TX09D70VM1CCA/CDA

# 2. Main Contents of Change

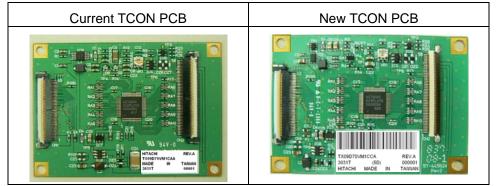
Change DC/DC convert circuit design(VGH \ VGL \ AVDD) and connector type.

DC/DC Convert	Connector (NOTE 1)	Label size (NOTE 2)	REV.
Current	LM2622-ADJ	FA5S050HP1R3000 (JAE)	(19)×(8) mm	А
New	R1211D002B	BL115-50RL-TAGF (SUNCAGEY)	(26)×(14) mm with barcode	В
